Drawing List:

Tice River Homes Legacy

A0

LEFT SIDE ELEVATION 'A'

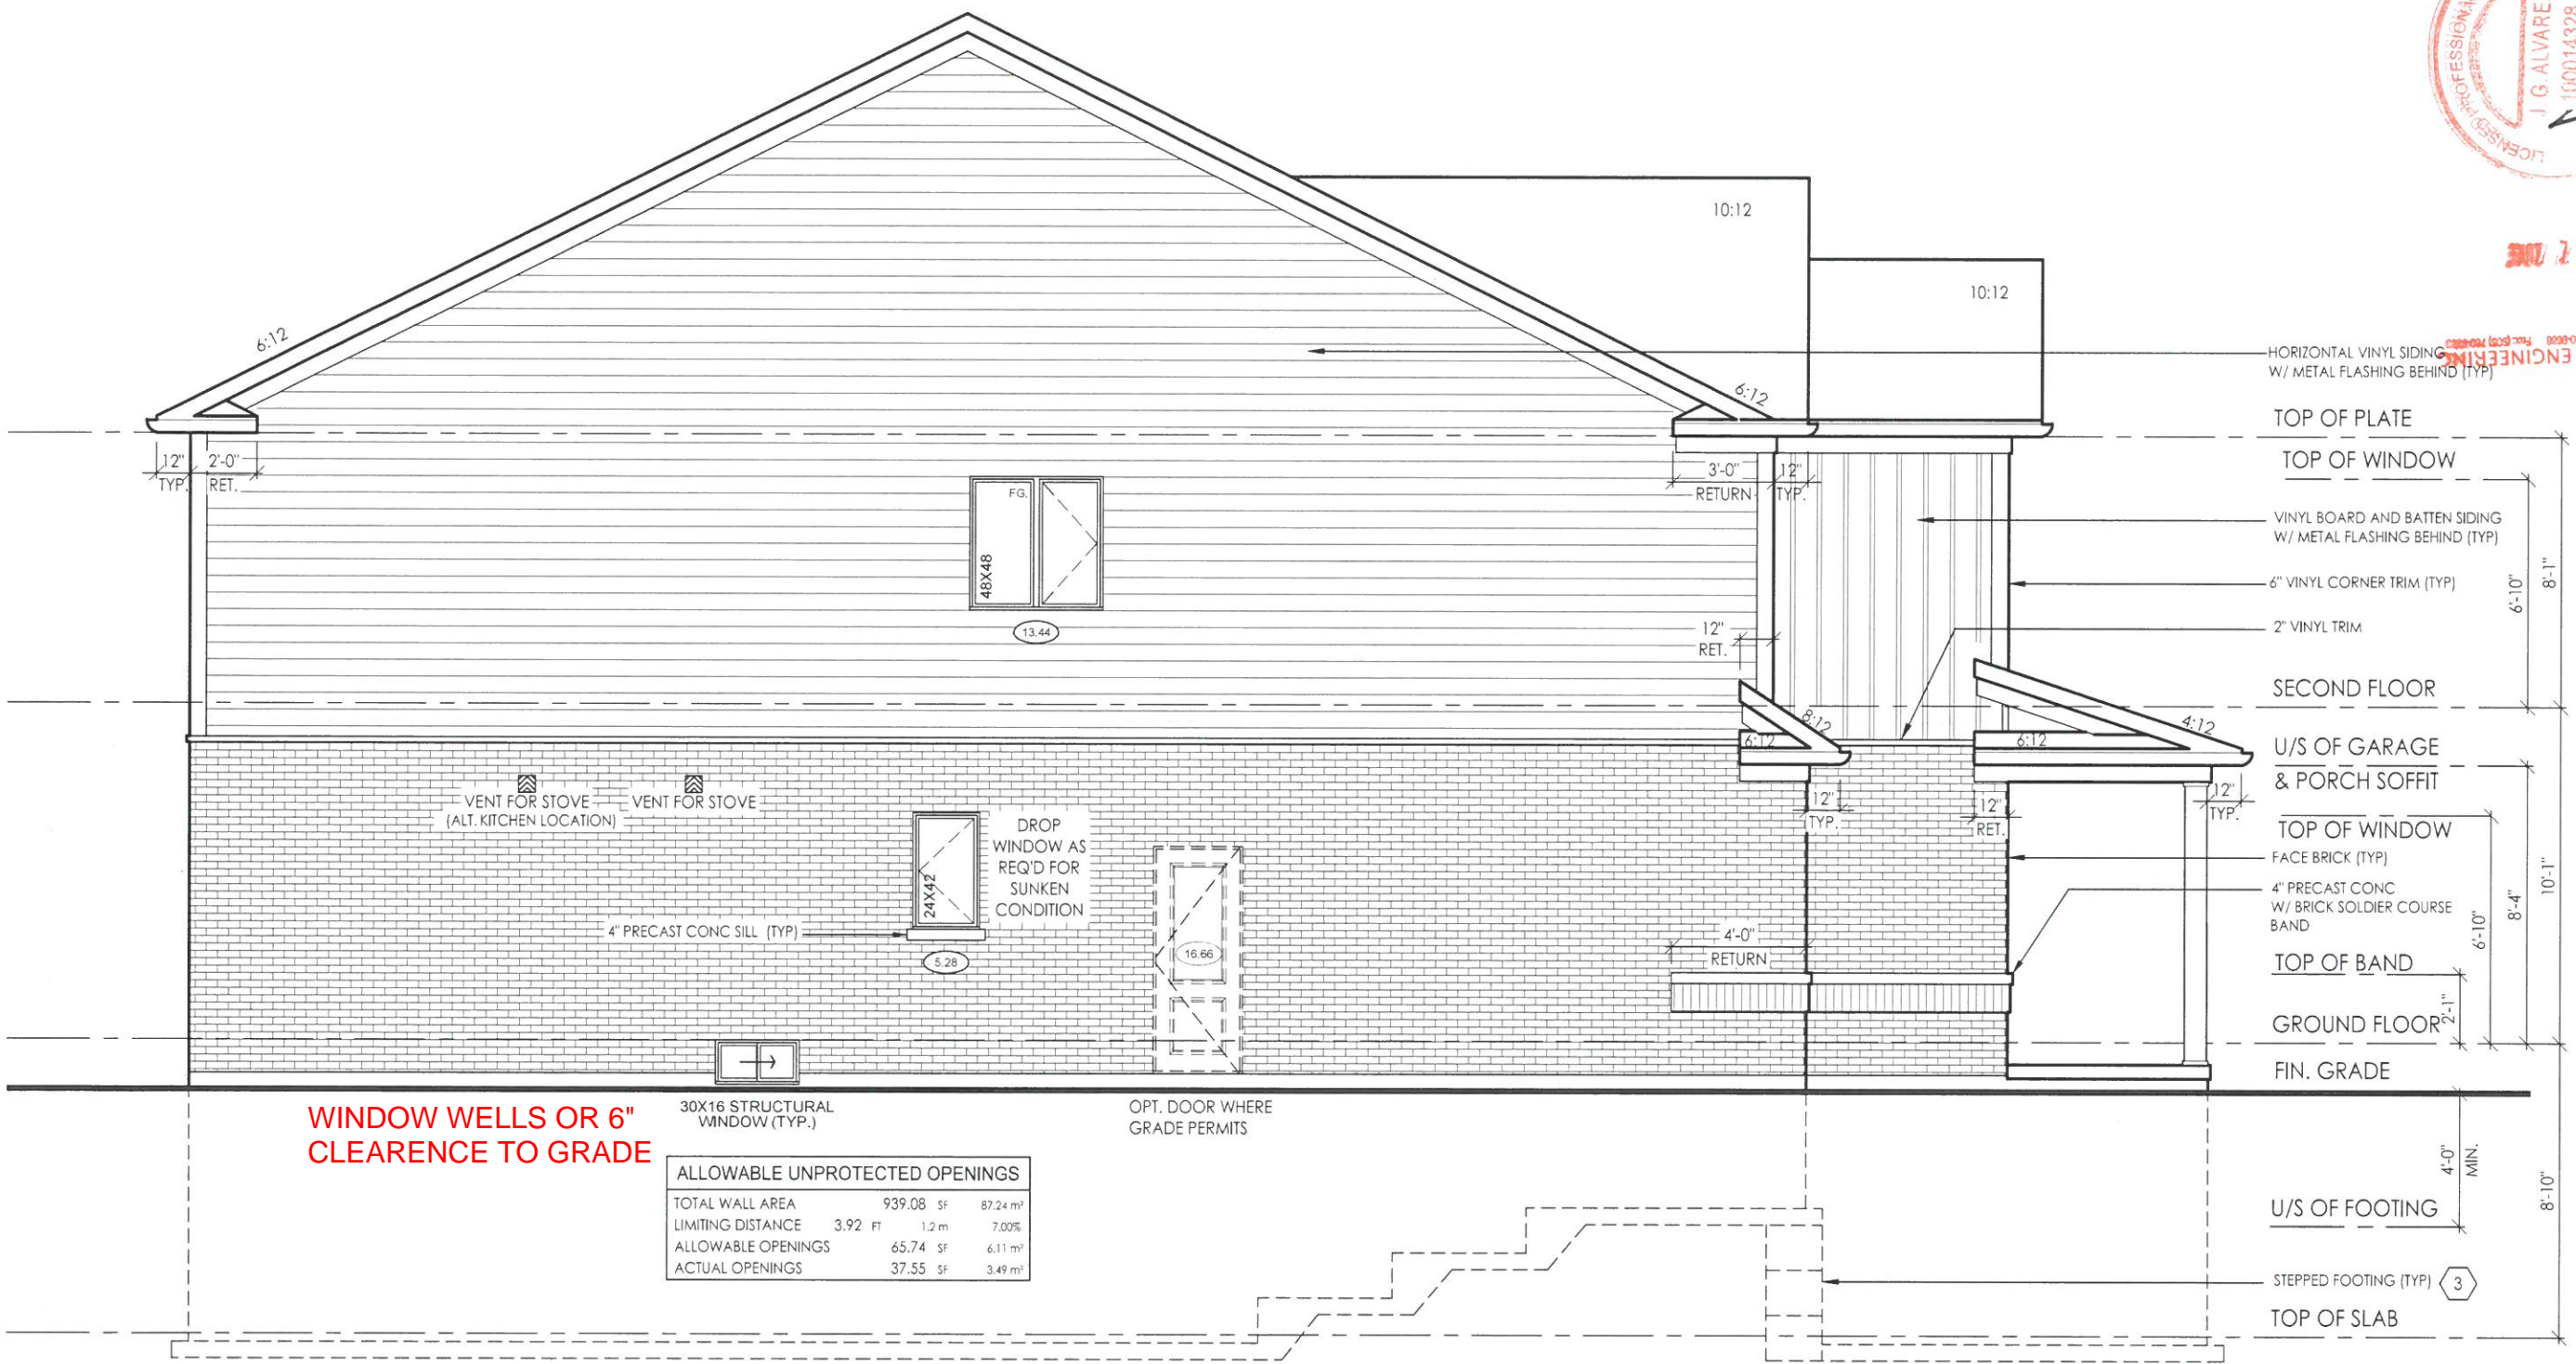
WINDOW WELLS OR 6" CLEARANCE TO GRADE
